Rezoning Transportation Analysis

Petition Number: 2019-130

General Location Identifier: 14920352

Date	Description
10-16-19	First Review

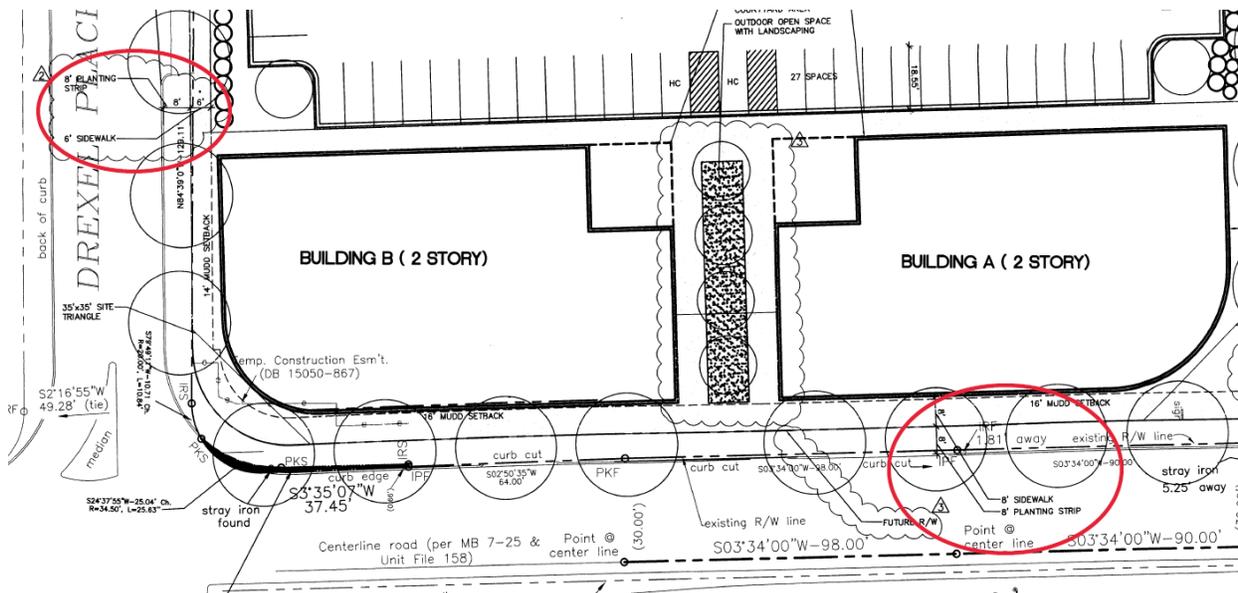
1. **Curbline** The proposed zoning district has a setback measured from back of the existing or proposed future curbline.
 - a. **Park Road:** The existing back of curb is in the correct future location.
 - b. **Drexel Place:** The existing back of curb is in the correct future location.

The site plan should show the curb and gutter labeled and dimensioned from the centerline for each road.
